HISTORIC DISTRICT COMMISSION  
STAFF REPORT

5:30 pm • January 27, 2020 • City Hall

# I.A 2035 INDEPENDENCE AVENUE - NEW SINGLE-FAMILY RESIDENCE

## II.A NEW ACCESSORY STRUCTURE - 705 DAVIS STREET

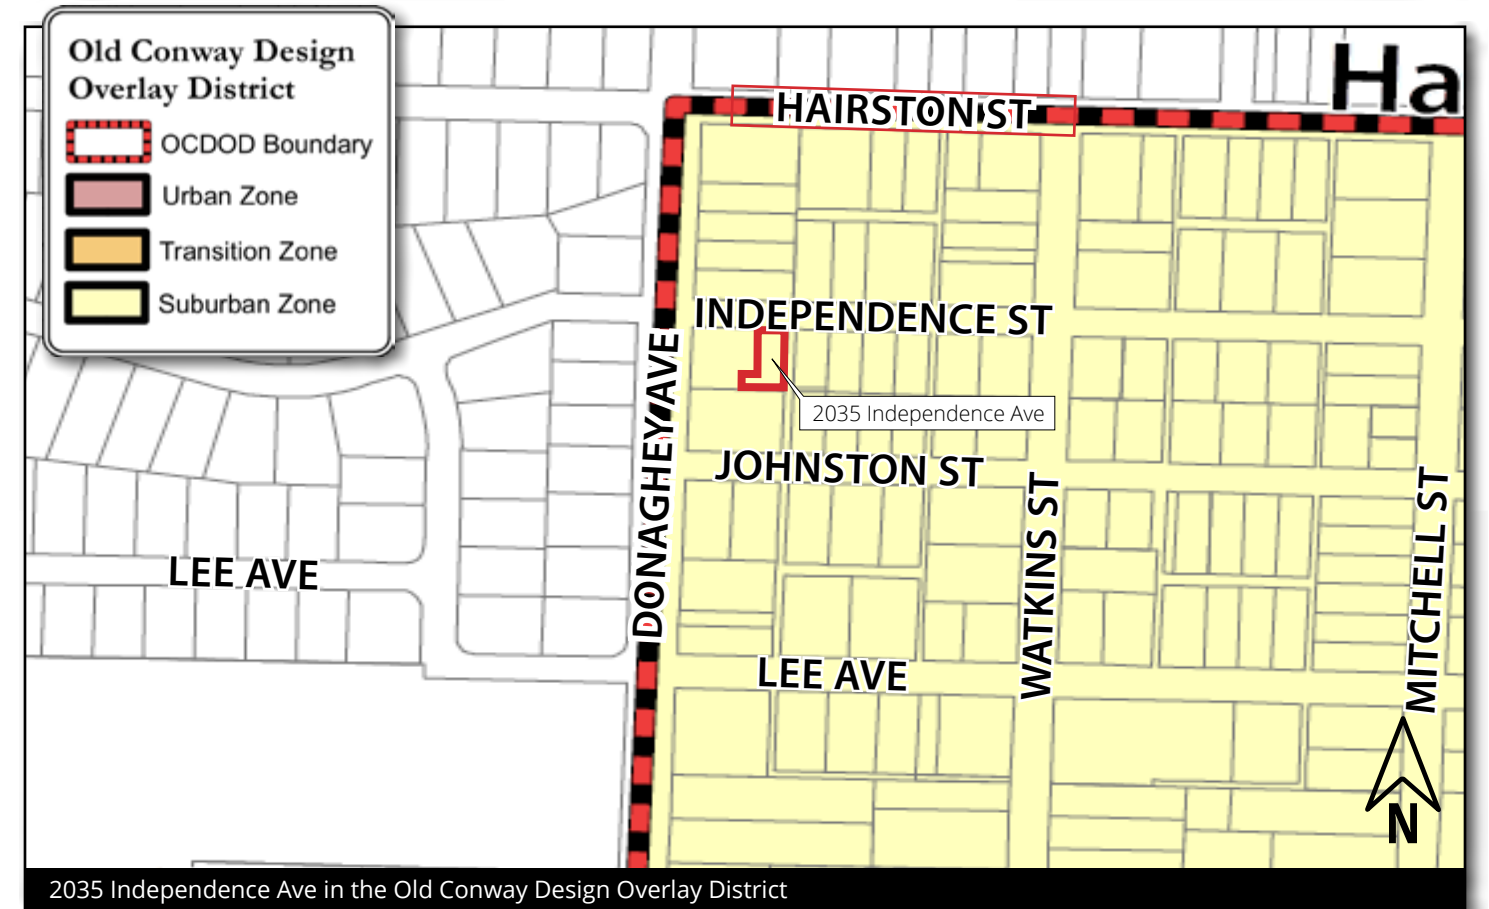
*The applicant is proposing parking in an attached garage that is recessed from the front of the house by 28 feet. The proposed parking is appropriate.*

*Sidewalk construction is required due to the scope of the proposed project.*

*Both the oak tree and gum tree in the front yard shall be retained.*

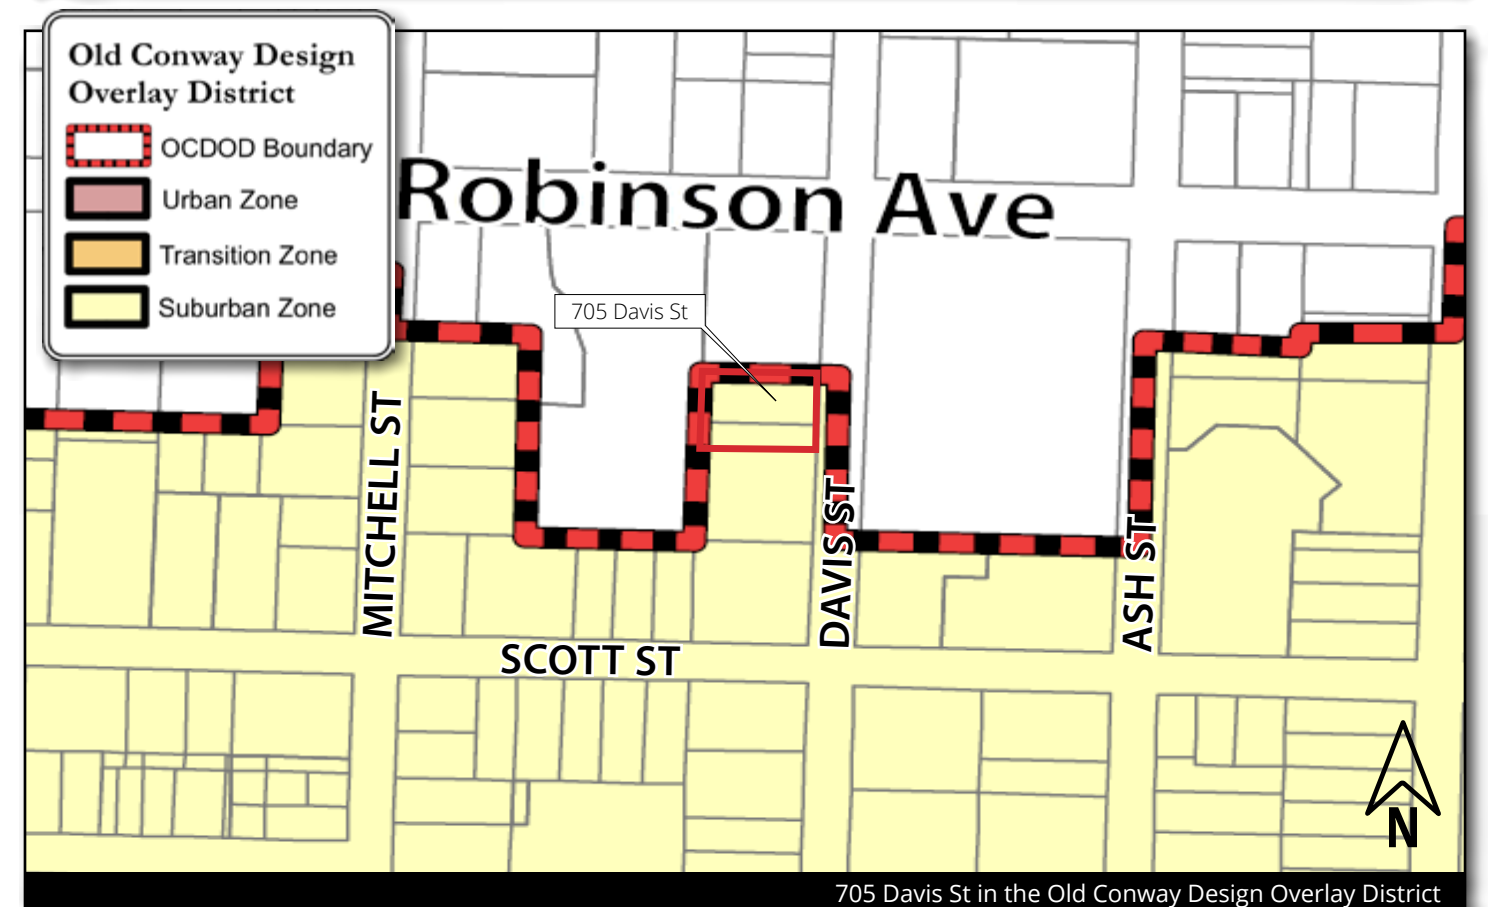
*The structure appears to respect the historical norms within the area. The structure will not exceed the height of the adjacent principal building.*

*The plans propose a hip roof that is not compatible in design and pitch to the roof of the primary structure. A gabled roof form would be more appropriate.*

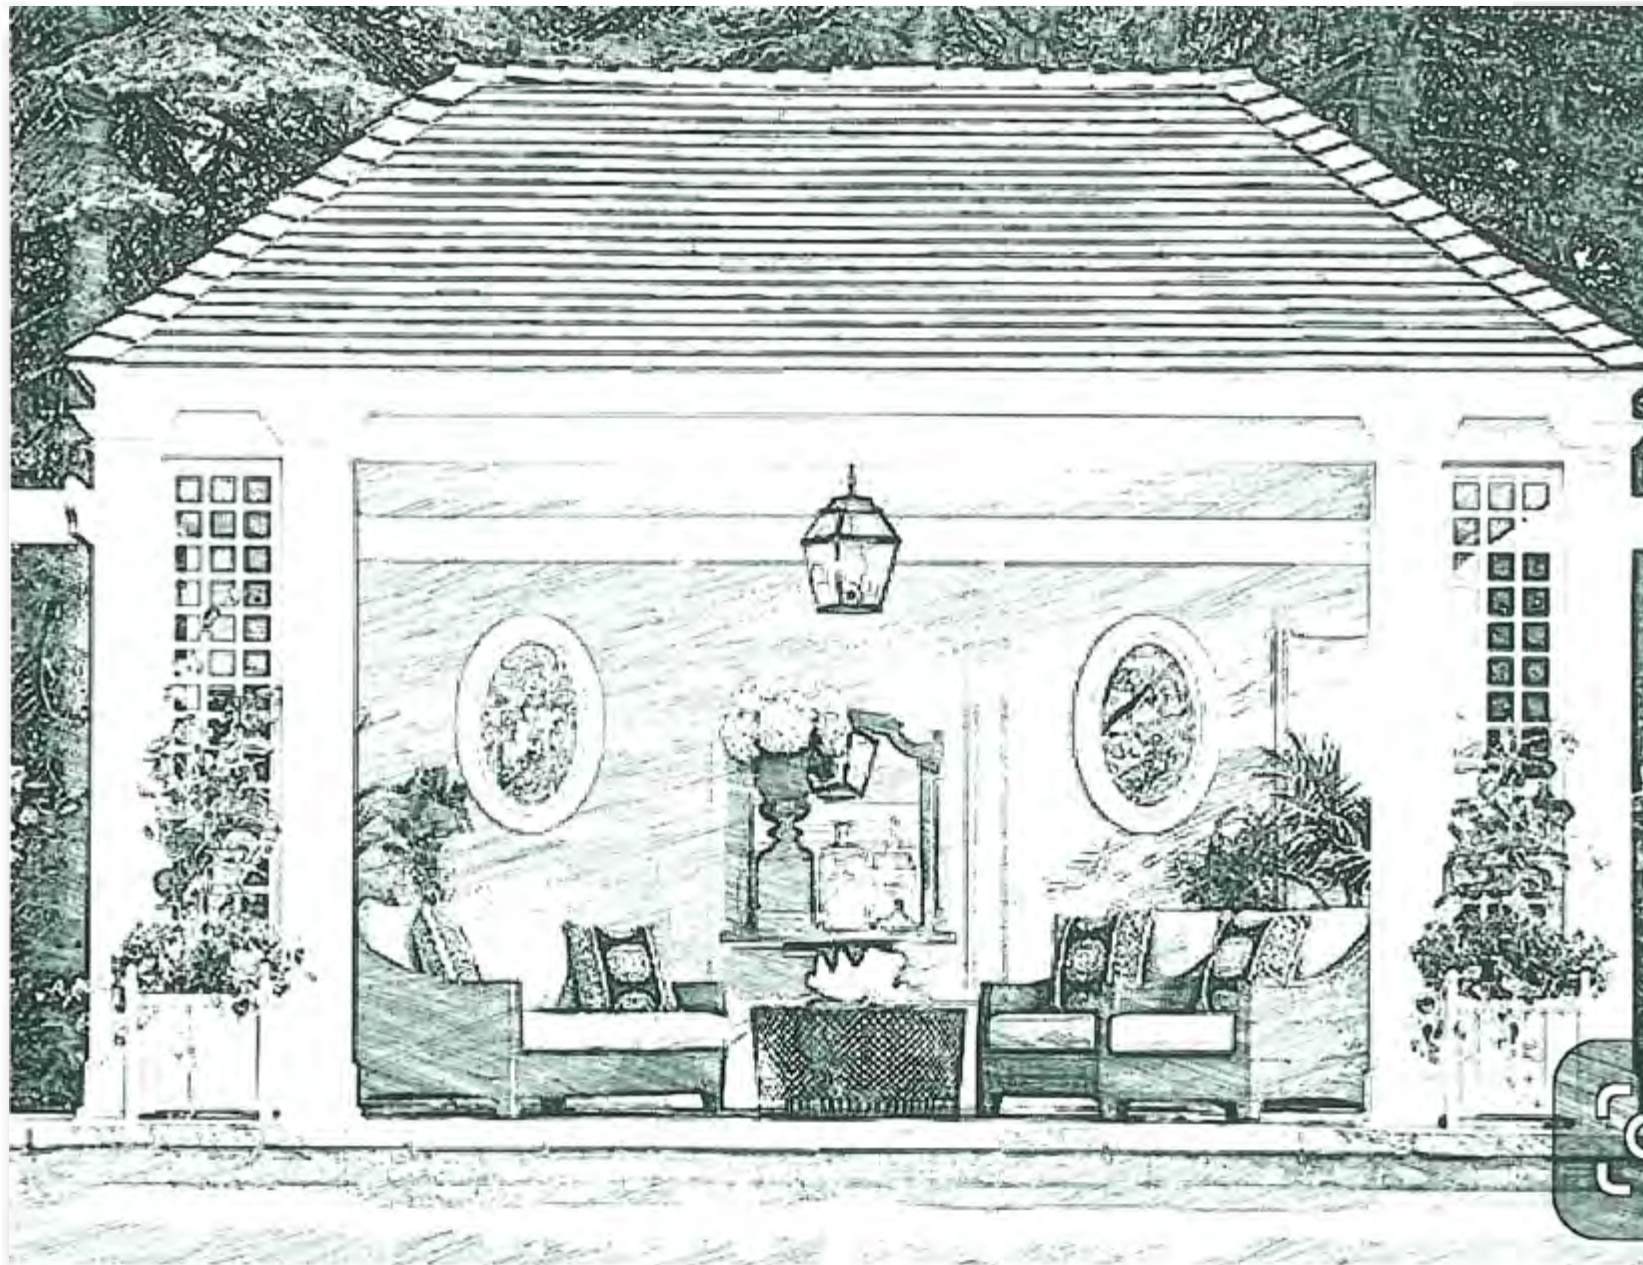
*The plans submitted for review do not indicate a proposed material. It appears the existing house is clad in wood siding. The applicant shall clad the proposed structure in an appropriate material including wood siding or cement fiber siding (Hardie board).*

1. The proposed accessory structure shall be clad in either wood siding or cement fiber siding (Hardie Board).
2. Revised plans shall be submitted to the Planning Director correcting the roof form of the structure to allow for a compatible design.
3. The applicant shall obtain a zoning variance for a setback reduction prior to the issuance of building permits.

Site plan

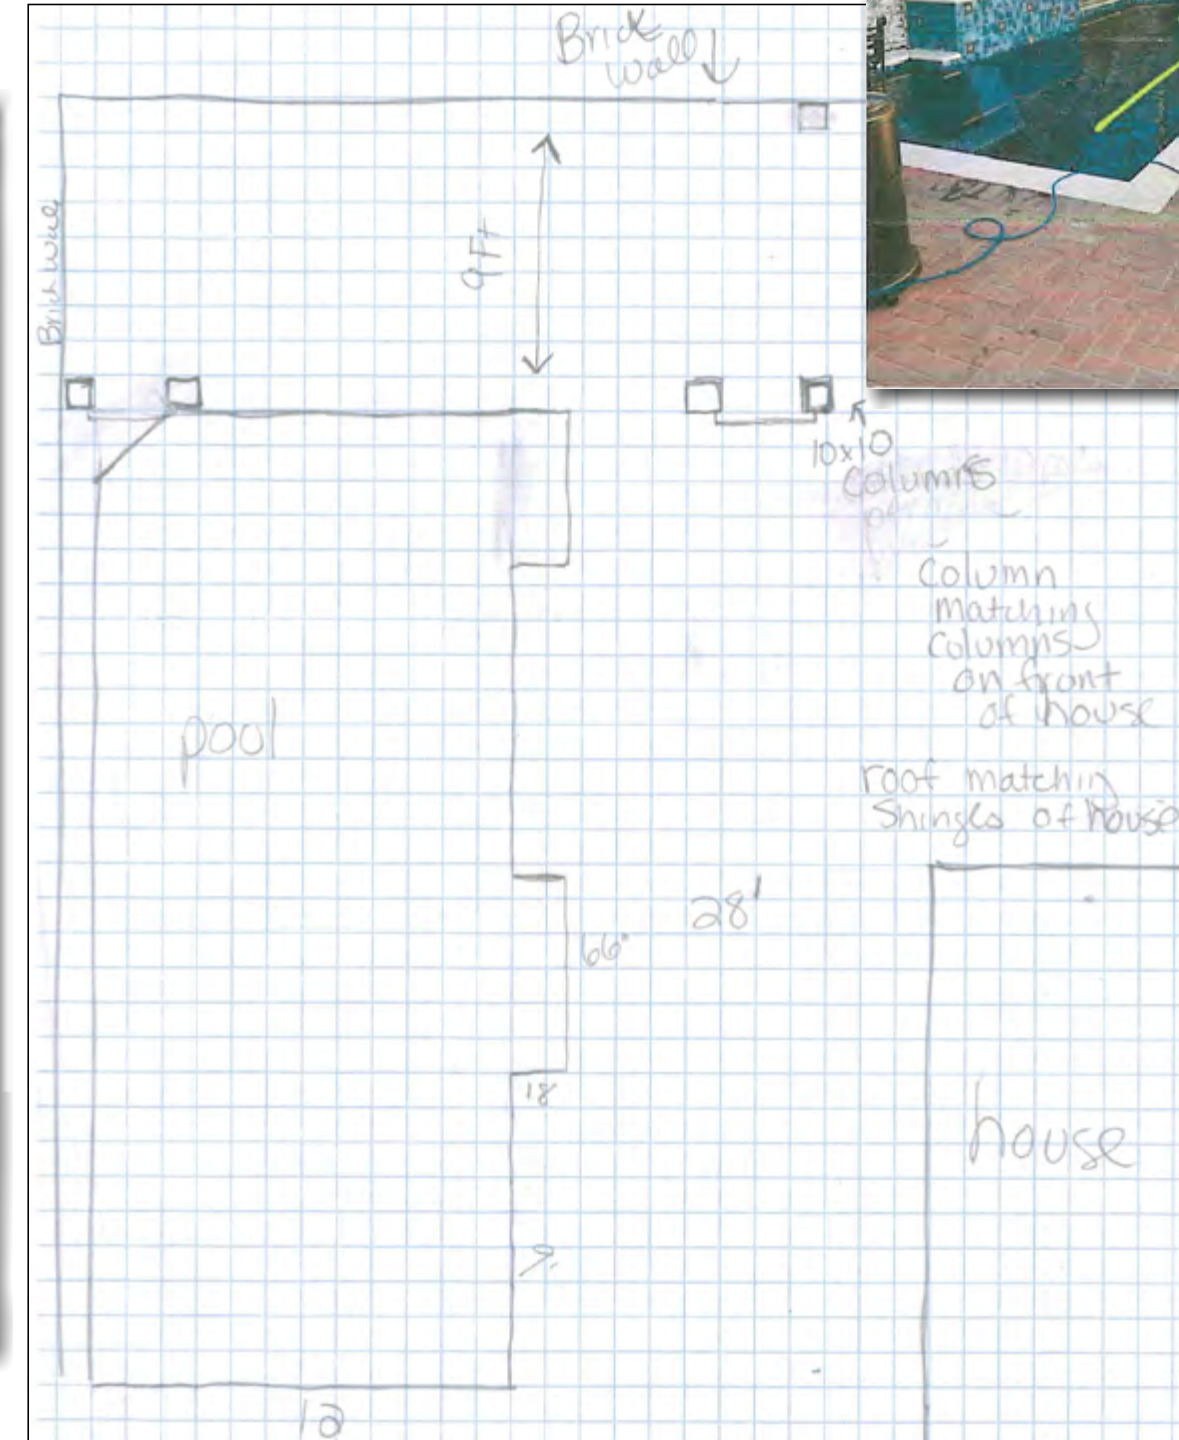
*As proposed, the setbacks will be 0' to the rear property line and 0' to the southern interior property line. The cabana is located to the rear of the principal structure when viewed from the primary frontage.*

*As proposed, the accessory structure does not meet the minimum setback requirements of the zoning code. A zoning variance would be required to allow any reduction of the required setback.*
